Santa Lucia Preserve Project

Final
Environmental Impact Report
Volume I: Response to Comments

**Santa Lucia Preserve Project
Final
Environmental Impact Report**

Assigned EIR No. 94-005
Planning Commission No. PC94067 (SCH 94083019)
Planning Commission No. PC94218 (SCH 95023036)

RANCHO SAN CARLOS
 LOCATION OF PROTECTED BASEFLOW REACHES

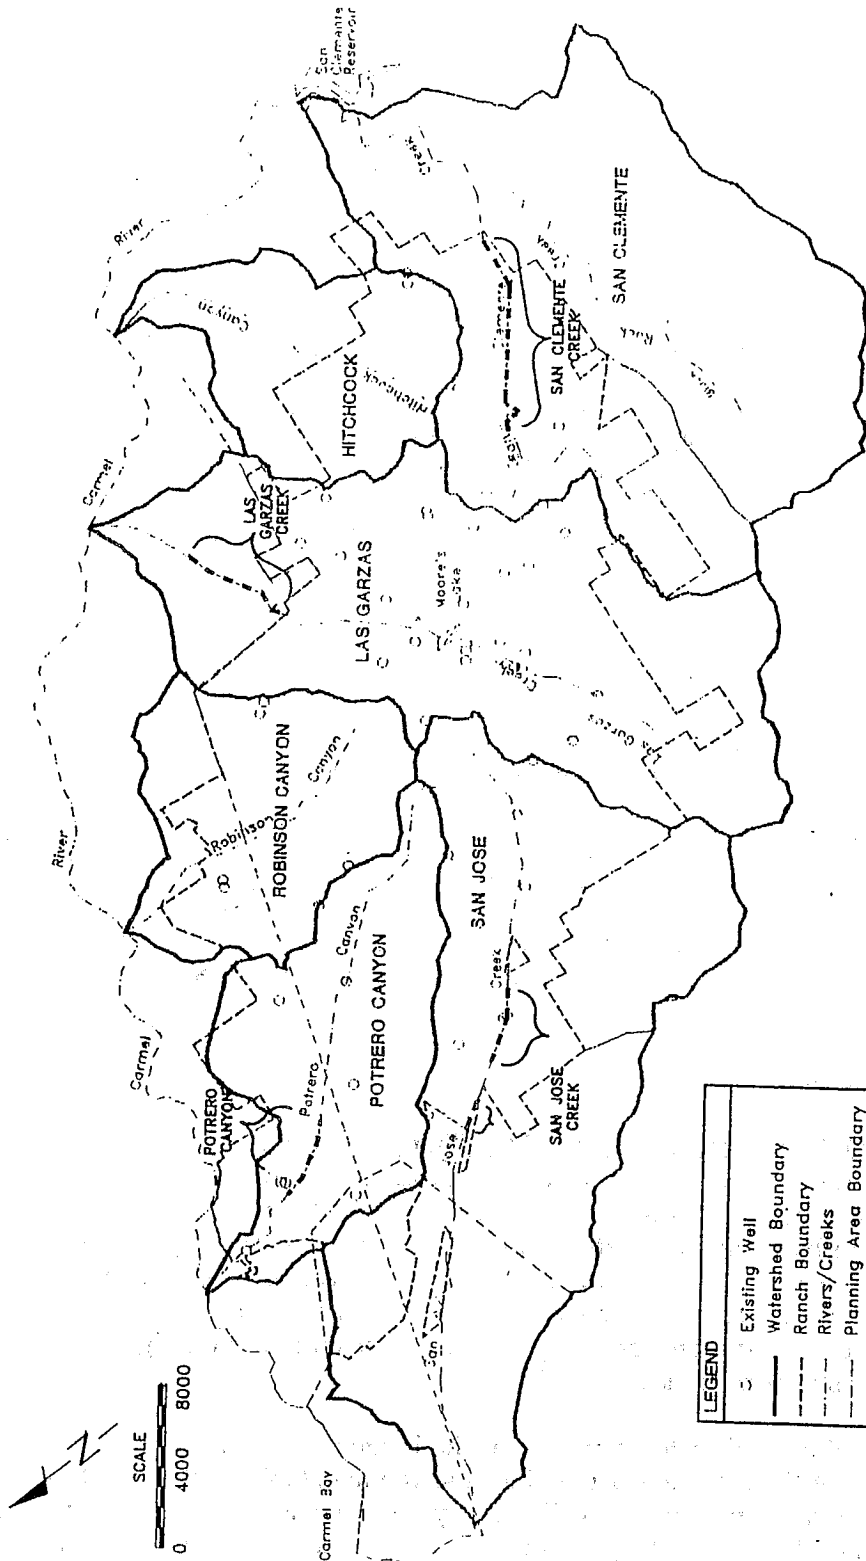
Page 8-45, para. 6 This paragraph discusses an additional mitigation designed to reduce impacts to protected base flow reaches by locating new wells at least 1,000 feet away from protected base flow reaches. Similar to the above comment, it is not clear how many of the future wells (as shown on the map in Figure 8-5), would be affected by this mitigation, and how this mitigation might affect the ability of the future water supply system to meet buildout demand requirements. 15

15. This mitigation measure would not substantially decrease the area available for drilling new wells. Assuming the protected base flow reaches along Potrero Canyon, and San Clemente and San Jose Creeks (the base flow reach on Las Garzas Creek is outside Rancho San Carlos) are each approximately 2 miles long, the area of exclusion for new wells is only 1,455 acres, or 7% of the Rancho San Carlos area. Therefore, there should be sufficient water to satisfy project demands at buildout. Anticipated locations of future wells, shown on Figure 8-5 of the draft EIR, will be adjusted accordingly to conform with this mitigation measure.

17. Approximate locations of the protected base flow reaches are shown in Figure 8-4a, Chapter 8, of the final EIR.
18.
 - (a) Refer to the response to Comment 9 above.

FIGURE 1: HABITAT FRAGMENTATION AND ISOLATION IN THE PROPOSED SANTA LUCIA PRESERVE DEVELOPMENT PLAN.

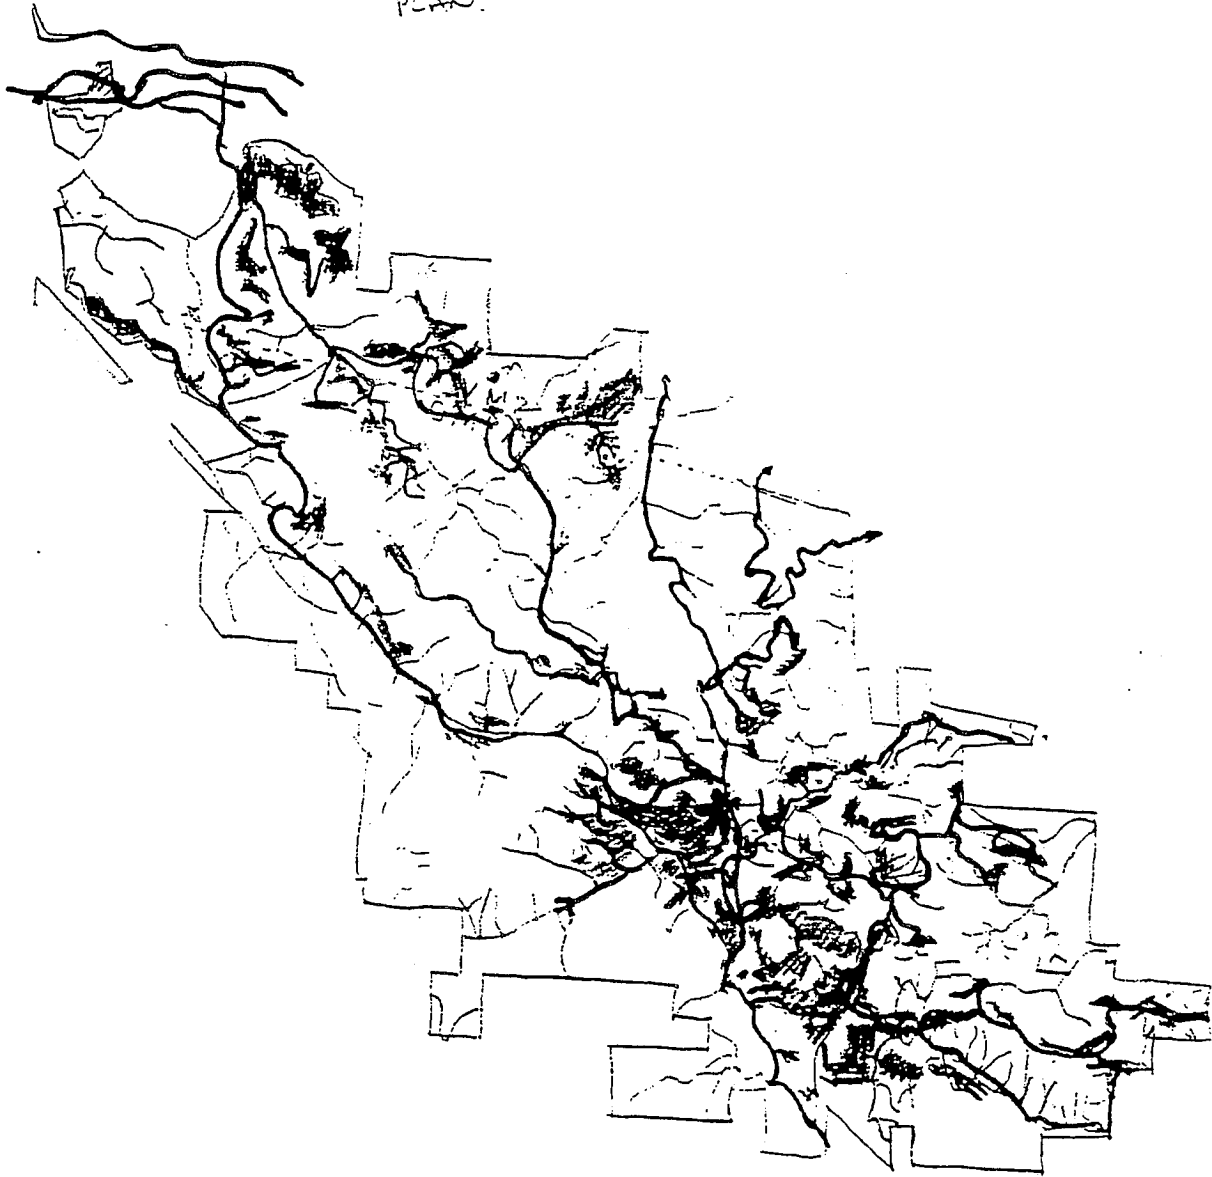
Fragmentation can occur at different spatial scales, and the proposed plan will, we believe, lead to significant fragmentation of all of the habitats on the scale of the Santa Lucia Property. As proposed, the development will intersperse significant human development throughout the property. In addition to the dwellings and buildings themselves, roads and driveways will be constructed throughout. The end result of this type of development and criss-crossing of roads is the fragmentation of what was once a continuous habitat without barriers to dispersal (Figure 1). Fragmentation degrades the quality of the habitat from what it once was, and we expect a decline in the number of individuals and diversity of species in the entire property as a result. Species with limited abilities to disperse (e.g. reptiles and amphibians), or species that are restricted to certain habitat types (e.g. willow flycatcher) would be faced with unsurmountable barriers and thus have sub-populations doomed to extinction. Large carnivores (e.g. mountain lions and bears) must range over large areas in search of dispersed prey. Fragmentation through the construction of barriers (e.g. roads, development) to these movements effectively reduces the available habitat for these species, and limits the ability of the habitat to support them. In addition, significant mortality of large carnivores results from road kills. For example, urbanization in Southern California fragmented and isolated mountain lion habitat in the San Joaquin Hills in the late 1970's, and mountain lions were extinct in this fragment by June 1990 (Beier and Barret 1990). Mapping the movement corridors of key species found on the property would be a logical first step in understanding the potential impacts of fragmentation through the construction of barriers.
